### FINAL ORDER

# Special Standards Request Form

<p><b>ANDERSON PERRY &amp; ASSOCIATES, INC.</b> 14000 E. WILLOW AVE., DENVER, CO. 80231</p>		<p><b>CITY OF STANFIELD</b> WATER SYSTEM IMPROVEMENTS RESERVOIR NO. 3 AND RECOATING OF RESERVOIR NO. 2 2012 PROJECT SITE PLAN</p>	<p>SHEET <b>4</b></p>
<p>THIS DRAWING HAS BEEN REFINED 50%. ADJUST SCALE ACCORDINGLY. BAR SCALE SHOWN IS ACCURATE.</p> <p><b>FOR REVIEW ONLY</b> NOT FOR CONSTRUCTION</p>		<p>DATE: 11/14/11 BY: E. ARNOLD CHECKED BY: A. BREE</p> <p>PROJECT NO.: 339-92 SHEET NO.: 4 DATE: 11/14/11</p> <p>COPYRIGHT 2011 BY ANDERSON-PERRY &amp; ASSOCIATES, INC.</p>

CITY OF  
STANFIELD, OREGON  
CITY WELL NO. 5  
ANTICIPATED WELL CONSTRUCTION

# RESERVOIR SITE SCALE: 1"=20'

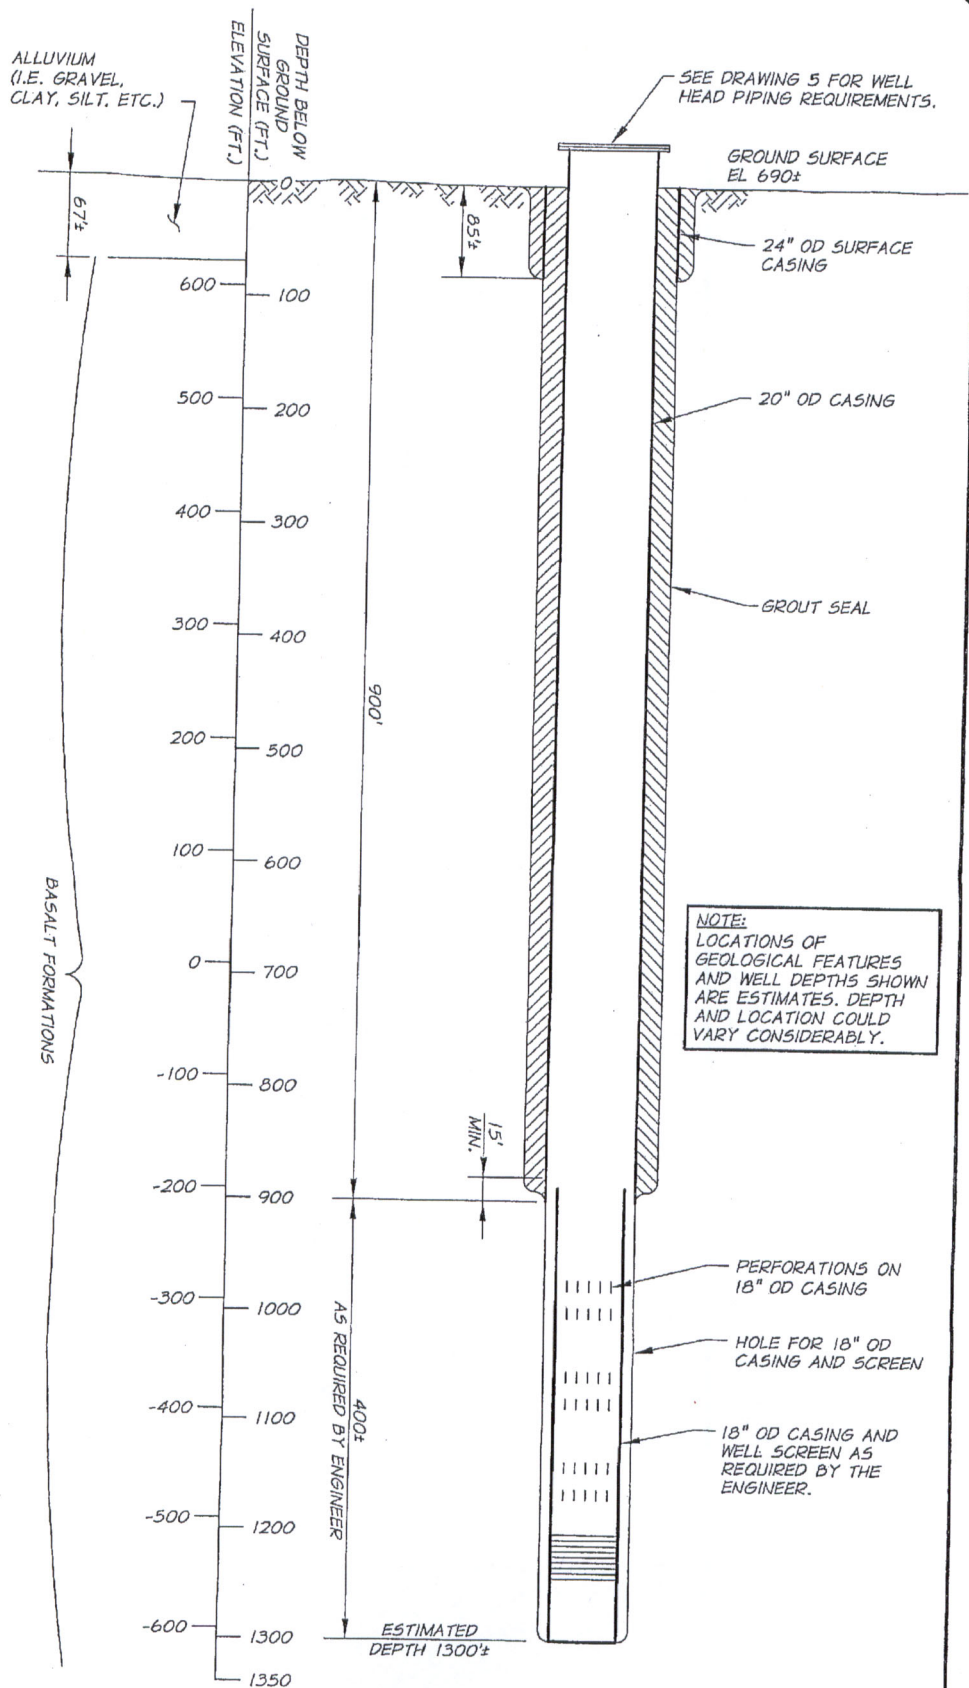
(5) The unusual site conditions which necessitate this request: Site plan (see attached) to contain all facilities

(including reservoir, pump station, etc.), property boundaries, drill equipment requirements & layout, concern of well  
interference, and provisions for future well serviceability require well to be located less than 50' from existing closed sewage line.

The Special Standards Request Form you submitted for owner: City of Stanfield, Start Card number 208746, is hereby approved for the following: You may install this well within 25 feet from a closed sewage line in the location agreed upon with the Department's representative. A stipulation of this special standard is that the well must be continuously cased and continuously sealed to a minimum depth of 900 feet below ground surface as described on your Special Standards Request Form. A deeper seal must be placed, if required, based on the formations encountered while drilling. All other standards must be adhered to. Your Special Standards Request Forms is enclosed.
